# CITY OF HOOD RIVER

PLANNING DEPARTMENT

Re: Recommendations for WACP Streets, Bicycle & Pedestrian Frameworks (File No. 2018-07)

## **STREETS FRAMEWORK RECOMMENDATIONS**

### Separated Bike Lane

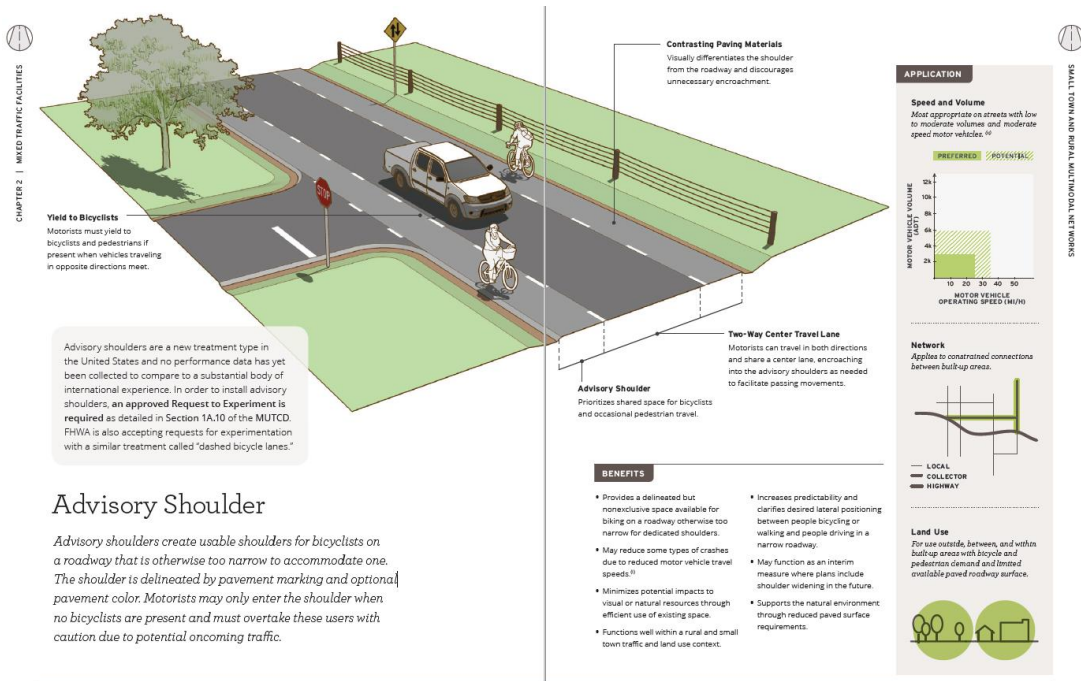
- Update the proposed Minor Arterial cross-sections (specifically "Alignment D" of the "Mt. Adams extension") to replace on-street bike lanes with physically separated bike lane as depicted in the Federal Highway Administration's "Small Town and Rural Multimodal Networks" publication (see image below). However, also consider maintenance requirements for physically separated bike lanes. The cross-section is intended to better accommodate novice and younger cyclists, and it provides an additional

buffer between vehicles and pedestrians. As depicted in the following image, the bicycle path returns the cyclists back to the road at intersection locations.

## Advisory Shoulder

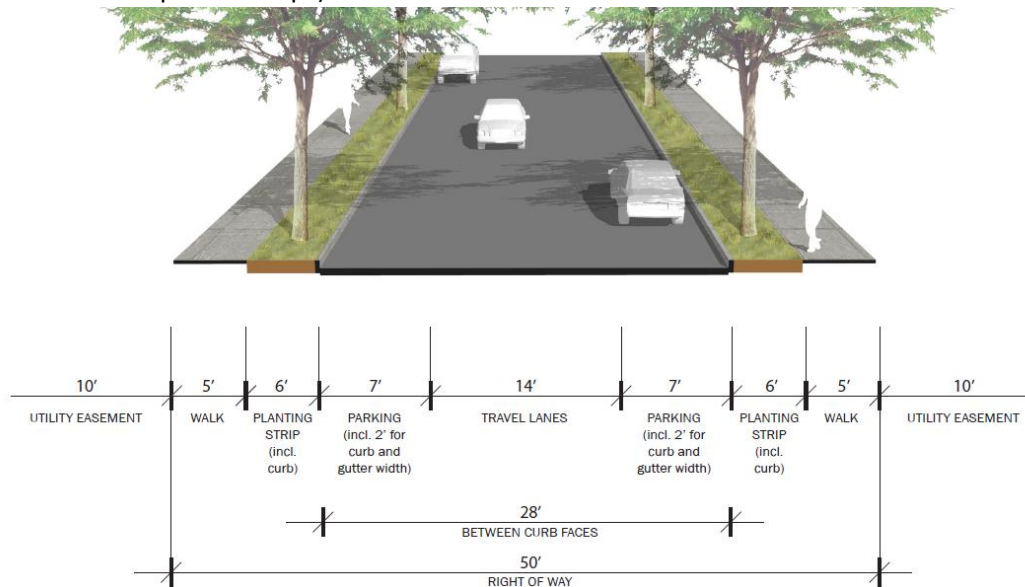
- The Commission recommends that “Neighborhood Connector” streets incorporate “advisory shoulders” where on-street bicycling shares space but is visibly separated from two-way, alternating, vehicle passing movements (see concept below). The cross section should include physically separated sidewalks that area minimum of 6 feet in width wherever possible. The suggested half-street cross section includes a 6-foot-wide sidewalk, 7-foot-wide planter strip, 7-foot-wide on-street parking, 4-foot-wide bike lane, all used in combination with a single 12-foot-wide vehicle travel lane that accommodates two-way traffic.

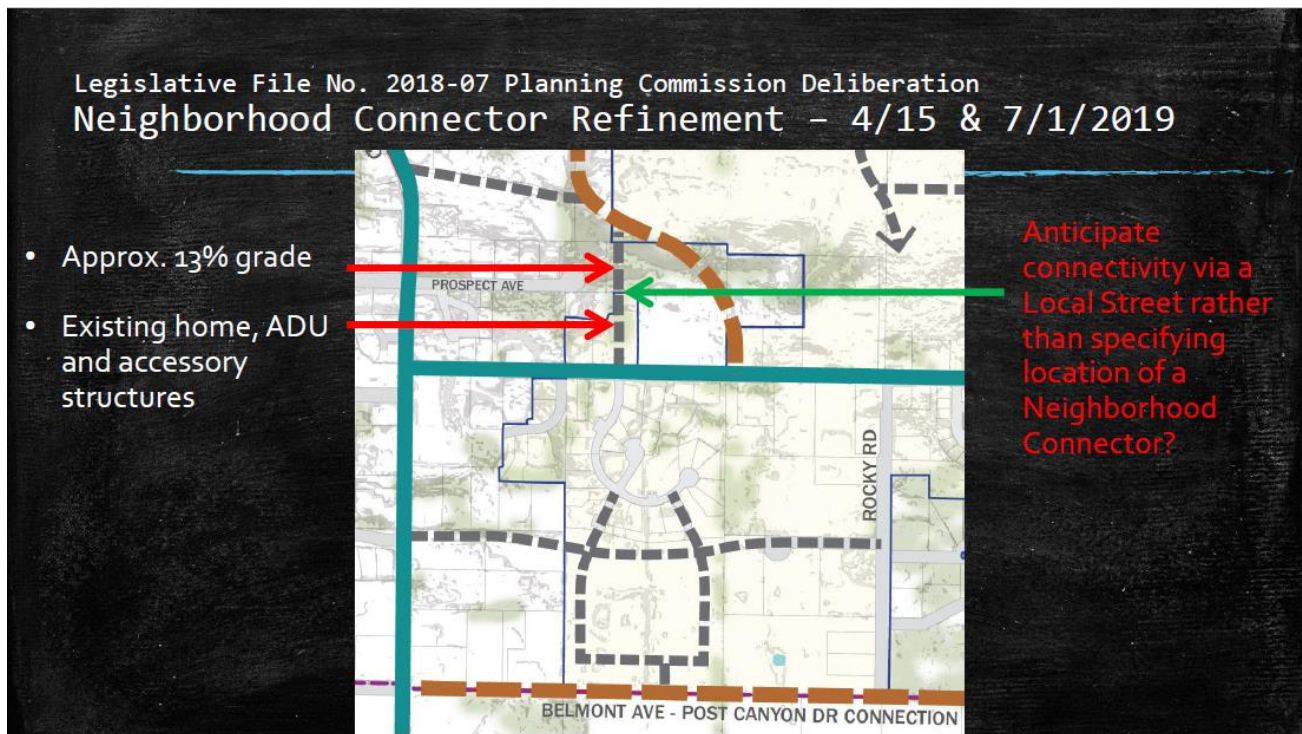
- In order to promote a strong entry corridor to Hood River along W. Cascade Ave., the Commission recommends a greater emphasis on “gateway” features by focusing on urban design, appropriate land use, transit features and the overall built environment

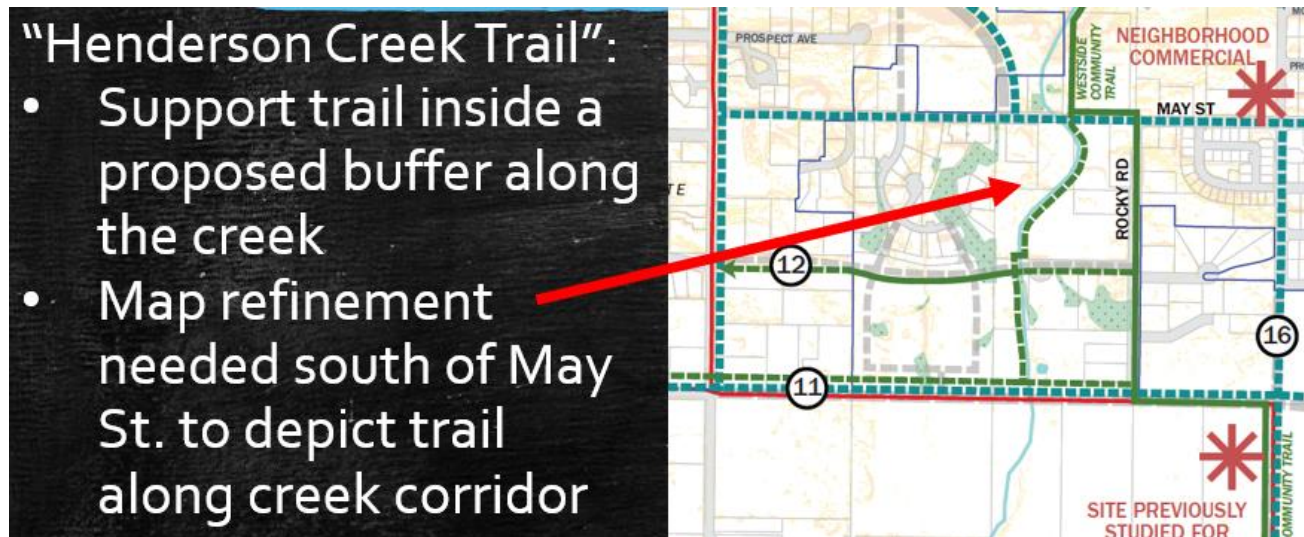
- Concern regarding "bikeability" of steep roads. Henderson Creek trail alignment may be preferable for bikes due to gentler grade in many areas, but the Framework currently anticipates use of 6-foot-wide trail by pedestrians only rather than a multi-use path.

## “Westside Community Trail”:

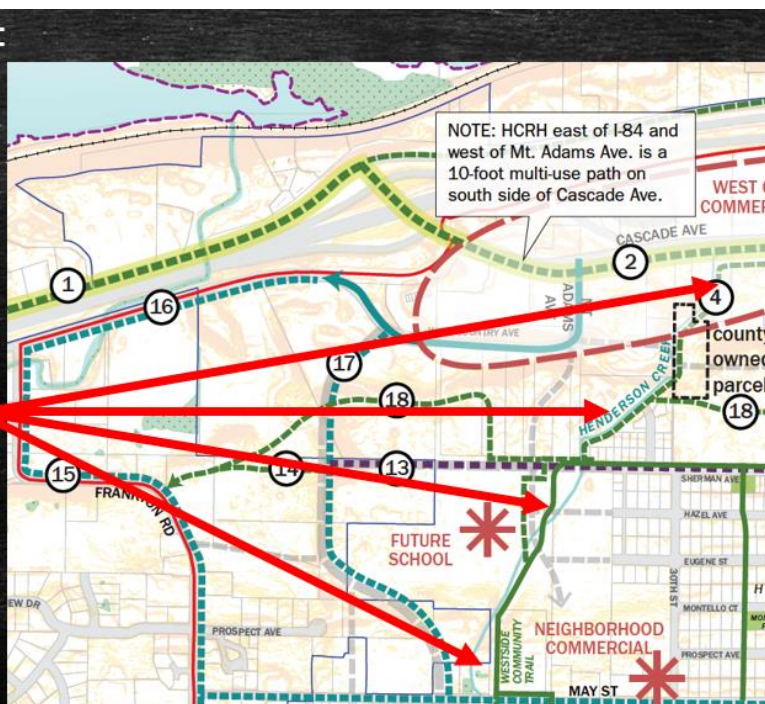
- Along Rocky Rd., pedestrians should not be on street.
- Retain existing segment immediately north of May St.

- The Commission recommends avoiding use of streets/sidewalks for portions of off-road trails (e.g. where Henderson Creek Trail crosses Sherman Ave.) but, if necessary and if constructed as a multi-use path, add seamless protected bike lanes where paralleling street.
- The Commission recommends eliminating an off-street pedestrian connection along a Neighborhood Connector street on school district’s property south of Sherman Ave. and west of Henderson Creek Trail.
- The Commission recommends ensuring east/west pedestrian connections on Hazel Ave. and Eugene St. between Fox Hollow subdivision and school district’s property.
- The Commission recommends providing a connection between the Mt. Adams extension (i.e. “Alignment D”) and the Henderson Creek Trail along north side of May St.

- Minimize segments relying on sidewalks with bikes on streets (avoid if possible).
- Map refinements needed north of May St.

- Support new trail
- Minimize segments relying on sidewalks with bikes on street (avoid if possible).
- Refinement of location needed near Frankton Rd.

- Trail Segment 12 off of Frankton Rd. should be via Carr Drive rather than Blackberry Dr., through Willow Ponds to Rocky Rd.

**Trail Segment 10**  
(10' off-street asphalt or concrete path):

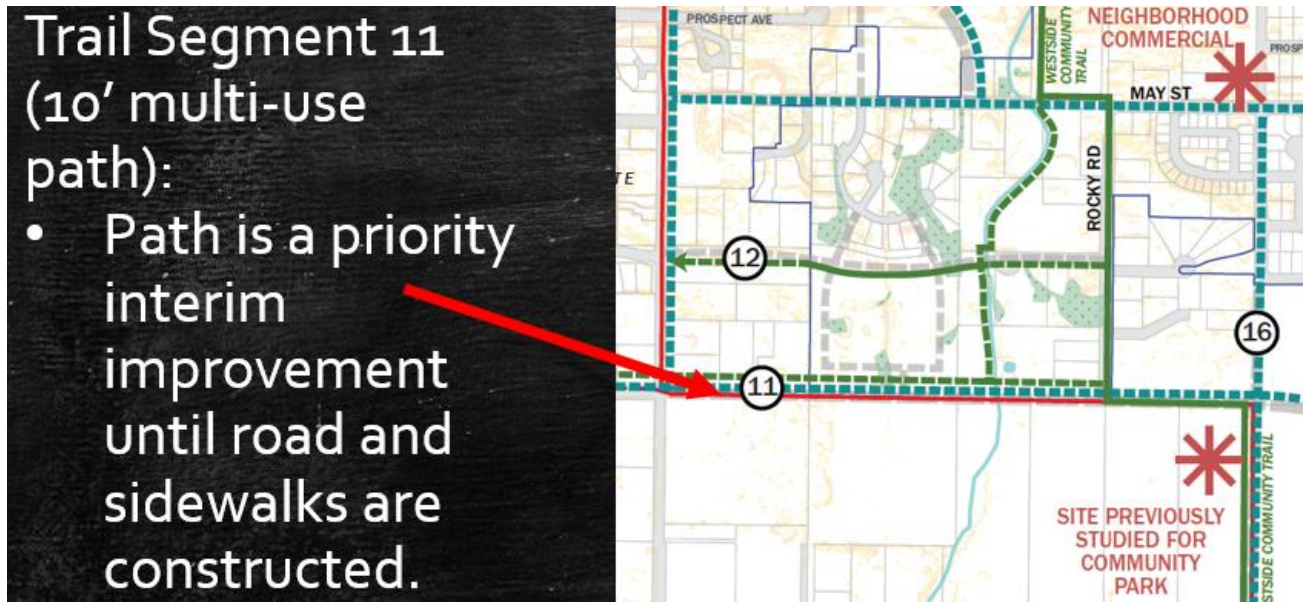
- The Commission recommends a portion of the Upper Terrace Neighborhood path (Path 10) is not constructed adjacent to a future Connector Street between May St. and Post Canyon Dr. (however, retain trail segment between Post Canyon Dr. and Belmont Dr.).

- Not needed parallel to future Neighborhood Connector street with sidewalks
